BOARD OF ADJUSTMENT MEETING
CITY OF ST. PETE BEACH
COMMISSION CHAMBERS

Wednesday, August 27, 2025
2:00 PM

COMMUNITY DEVELOPMENT - PLANNING

Date: **May 19, 2025 – Original / August 15, 2025 - Revised**

Figure 4: Site Layout Plan (N.T.S.) – Revised for August 2025 Board of Adjustment hearing

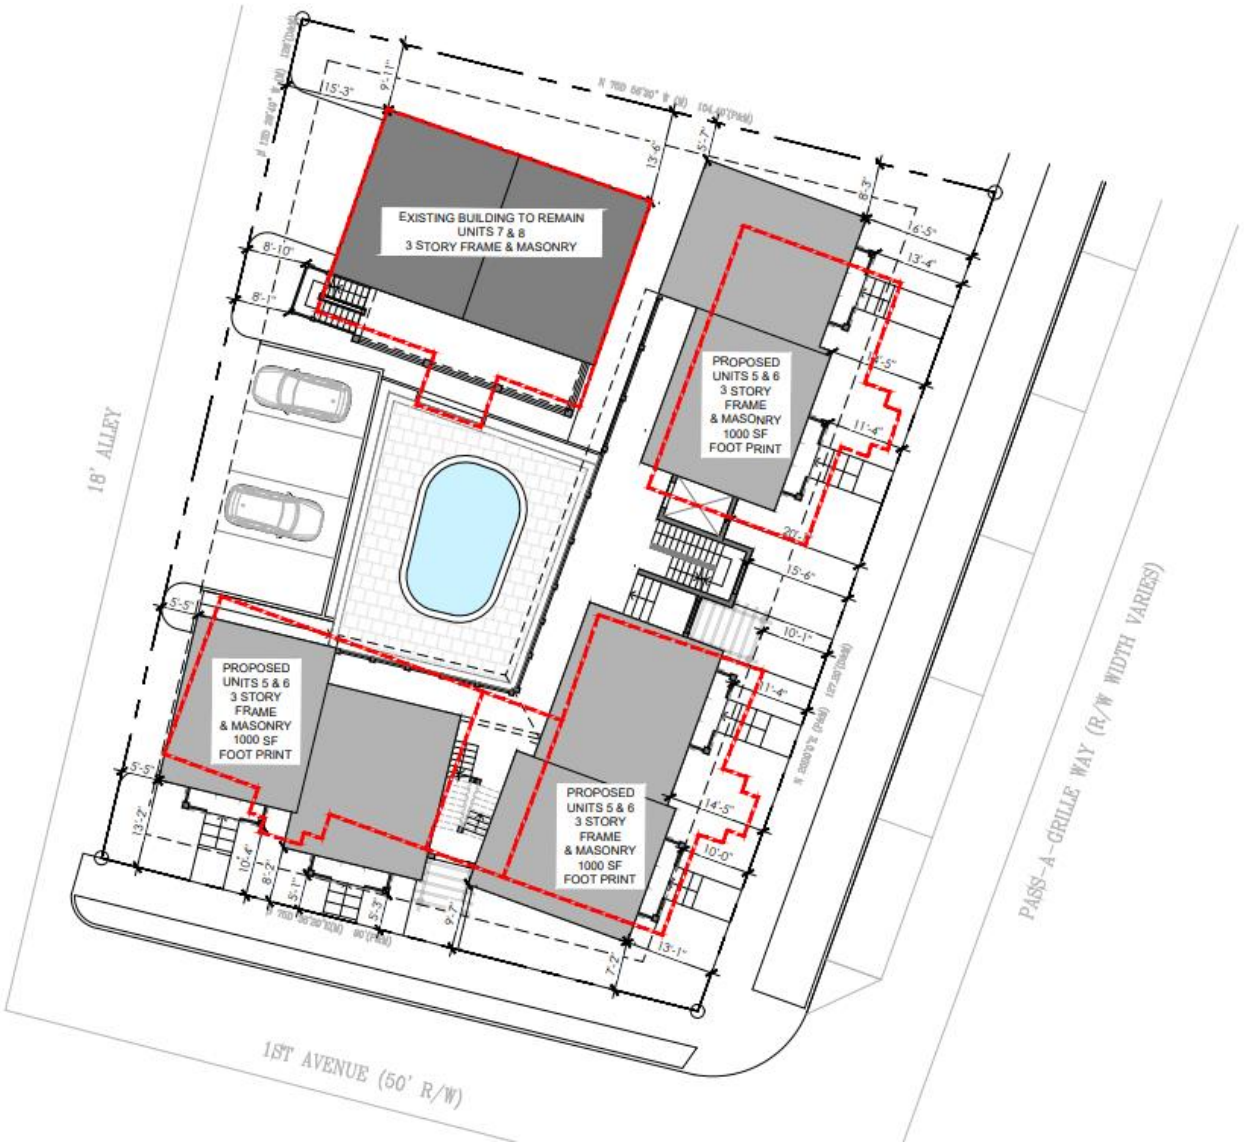
Staff finds the setbacks of the stairs and Units 5 & 6 building proposed in the revised plan set to be in general keeping with the existing location of these structures on the property. The stairs are a simple switchback design and are not of a mass or placed in such a way that present a significant visual encroachment toward the alleyway. The extension of the stairs appears to accommodate the addition of a third-floor deck which will be accessed from doors in existing window openings, and while the stairs may be able to extend into the courtyard rather than the rear of the property, Staff finds this contrary to the intended use of this space for the Courtyard Apartment building type.

Staff does find support for the rebuilt stairs to encroach into the western alleyway frontage, and for the Units 5 & 6 building encroachment should adequate justification for the additional living square footage be provided. The applicant's reconstruction of these dwelling units is not being undertaken voluntarily but as a response to the damage sustained to the structures, and the applicant is required to both elevate the structure and comply with current parking requirements. Other property owners in Pass-A-Grille have the option to maintain their existing nonconforming setbacks and parking conditions, which is not available to the applicant in this instance due to the extent of damage to the two eastern structures as relayed by the City's inspector.

Figure 5: Floor Area Calculations

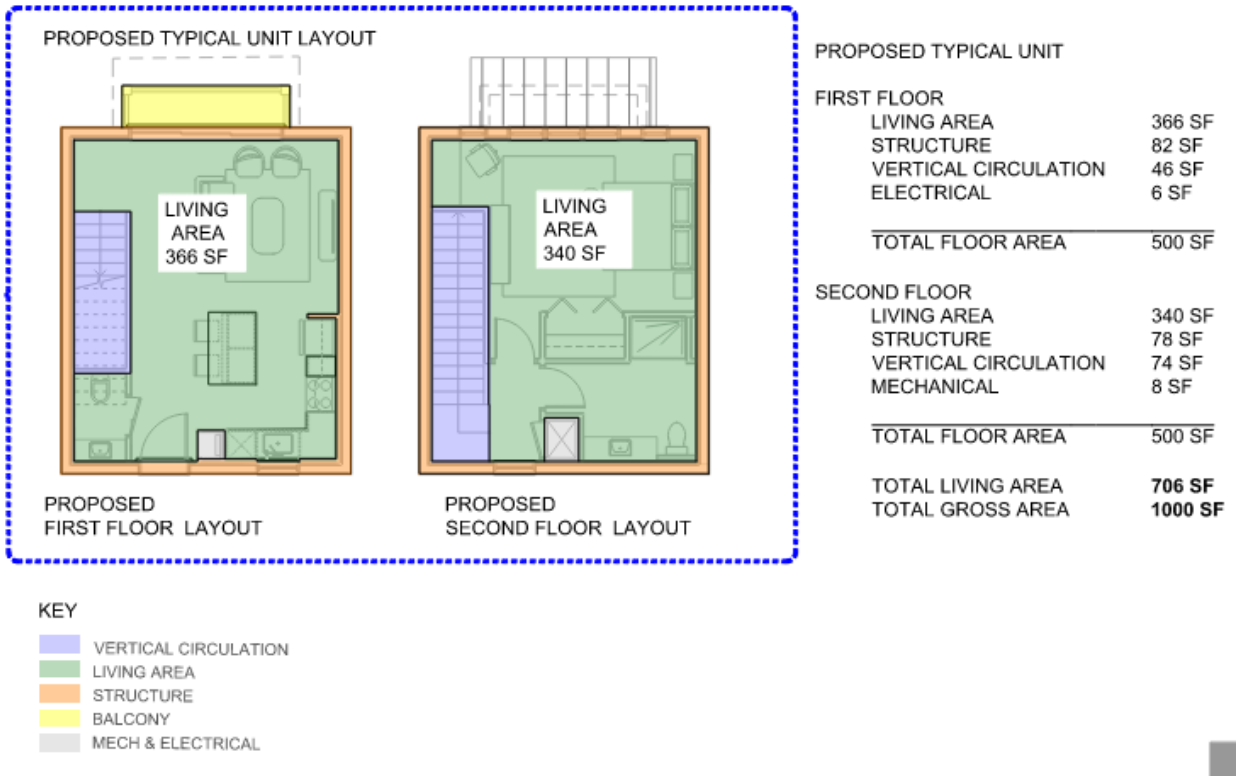
existing developed living square footage by approximately 210 square feet. The applicant's narrative does not appear to directly support how this additional square footage is necessary to accommodate essential code and FEMA/ADA compliance requirements, as stated in the narrative. While Staff does not expect an exact justification for each square foot of living space proposed above the existing, Staff does ask that the applicant provide general justification for the need rather than preference for this additional square footage. Additionally, Staff requests an explanation of why vertically-stacked units result in the need for more square footage than the current proposal, especially as it appears it would exclude the need for 120 square feet per unit that could be accommodated through access via the exterior walkways. The applicant's architect provided some information as to the Fair Housing Act requirements necessary to be accommodated with single-floor housing units at this case's second Technical Review Committee, which Staff requests be expanded on at the hearing.

staircases, required connections, increased wall thickness, and to meet FEMA requirements, but Staff does not understand how that is justified in the calculations provided. Additionally, it is unclear from the revised narrative how vertical stacking of units would result in a greater required square footage. The applicant and architect stated at the August 13, 2025 Technical Review Committee meeting that vertical stacking introduces Fair Housing Act compliance requirements for both living floors, but indicated that the square footage needs would remain approximately the same with the subject proposal.

2) Staff has calculated that approximately 195 square feet of interior developed living area is additional to the necessary first-floor powder room, and vertical circulation area addressed in the prior question. The application states that is necessary to meet modern code, FEMA, and ADA requirements, but Staff requests general justification for how that is the case. It is not clear, for instance, if the kitchen island or size of the living room area on the first living floor is necessary to meet a code requirement or instead (or in addition) intended to align with modern amenity expectations for the type of development.

Figure 3: Fence Proposal: Service Lot (East) Request

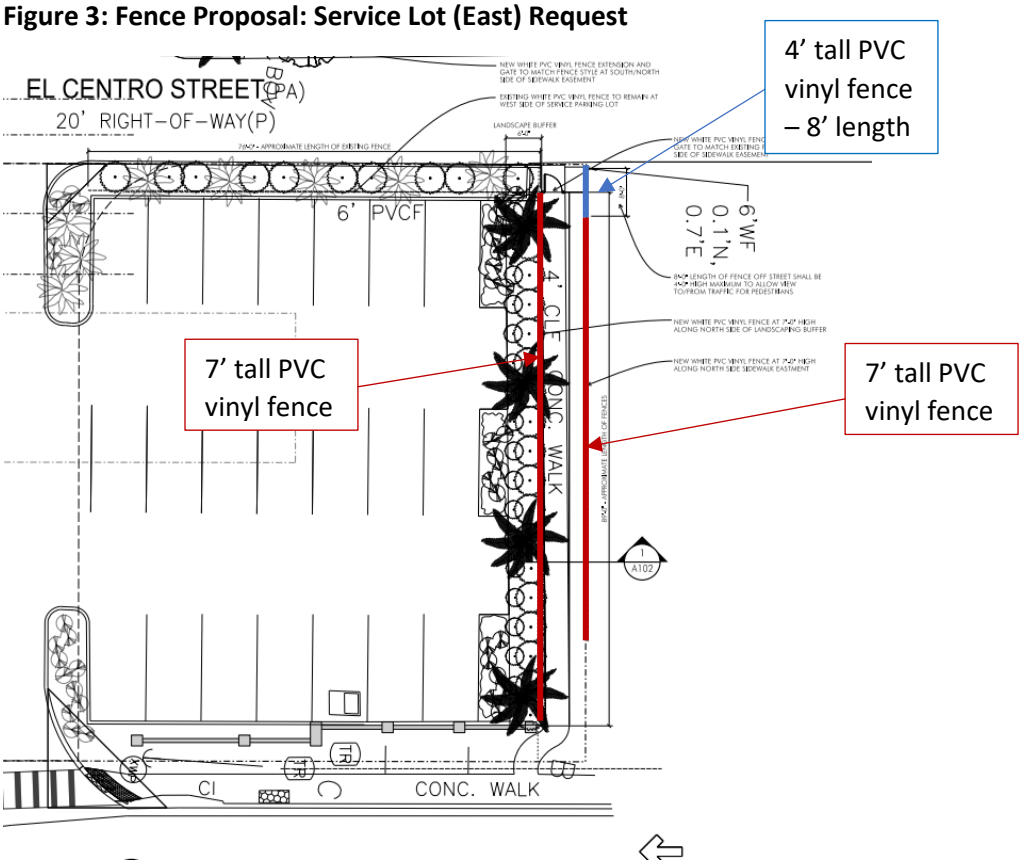
Both the service lot and beach walk fences are proposed to have a step-down portion to four feet in height at the El Centro St. property line for the portion abutting the adjacent residences to provide visibility for pedestrians crossing the road. This step-down will be eight feet along the northern side of the service lot, and six feet in length along the northern side of the beach walk.

The fence height request is made by the owner of the Don CeSar Hotel, but per the narrative is based on a request from the adjacent Don CeSar Property Owner's Corporation to provide additional security and screening from the service lot and new ballroom parking area. A prior owner of the property did undertake the replat that created the frontage conditions to which a variance is requested. However, the original platted lots that comprised the service lot and beach walk property would have faced similar restriction in fence height along the portions facing El Centro St. and Gulf Blvd, albeit with lower setbacks than contemplated here due to the zoning in place at the time.

Figure 4: Site Plan Showing Front Staircase Variance Request

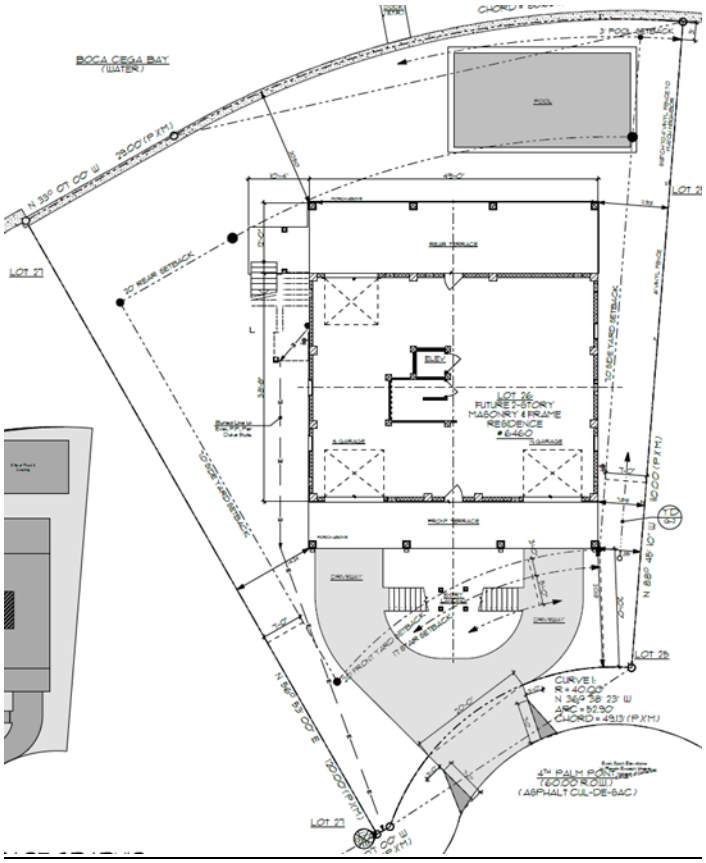
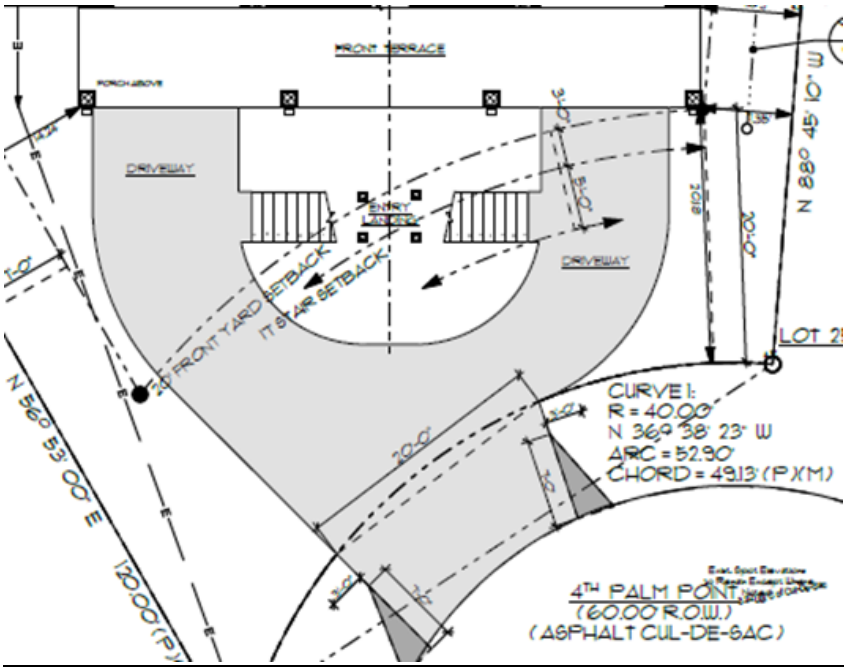
The applicant is requesting approval for the proposed elevated exterior stairs to encroach 5 feet into the required 17 foot front setback, representing a 29% encroachment. It is noted that only a portion of the split staircase would fall within the setback area.
